STAGE 3 ROAD SAFETY AUDIT REPORT FOR EDINBURGH TRAM NETWORK

Report Reference:-
Airport – York Place Final Stage3.

Date 06.04.2014

LOCATION. Section 1C. York Place at Tram Buffer

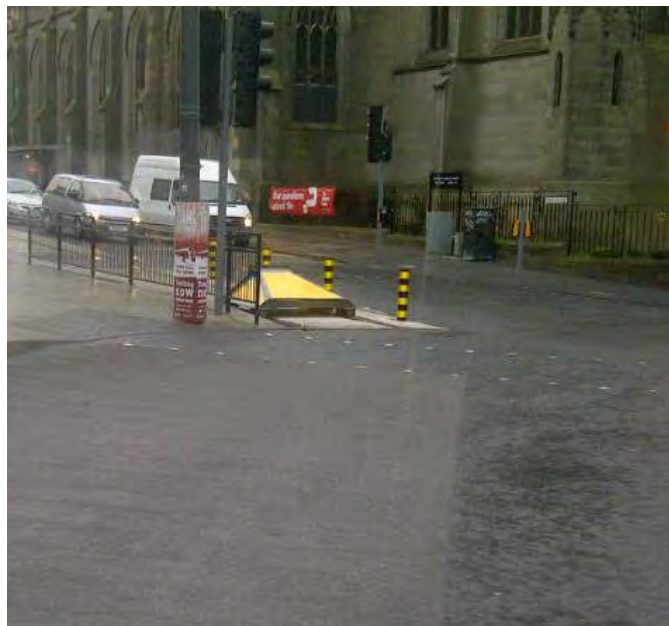
SUMMARY. Risk of vehicle impact with tram buffer.

The works at the Tram Buffer were incomplete at the time of the site visit on 12th February. The area around the buffer was protected by temporary traffic management. Eastbound vehicles in the nearside lane turning right from York Place towards the Picardy Place roundabout, were observed encroaching into the offside lane forcing cars in this lane towards the temporary barriers around the proposed buffer location. Poor lane discipline here is likely to force some cars towards the buffer, risking a collision and slight or serious injury to vehicle occupants.

The buffer and the deflection area behind the buffer should be protected by a series of passively safe reflective bollards that if hit can be quickly replaced. The audit team have been advised that “Visiflex” bollards in “NAL” sockets are to be provided around the area of the buffer along with retro-reflective markings on the buffer.

Since the site visit on 12th February bollards have been provided around the buffer and the buffer has been made more conspicuous with the application of reflective markings. The Audit team consider these measures to meet the above recommendation.
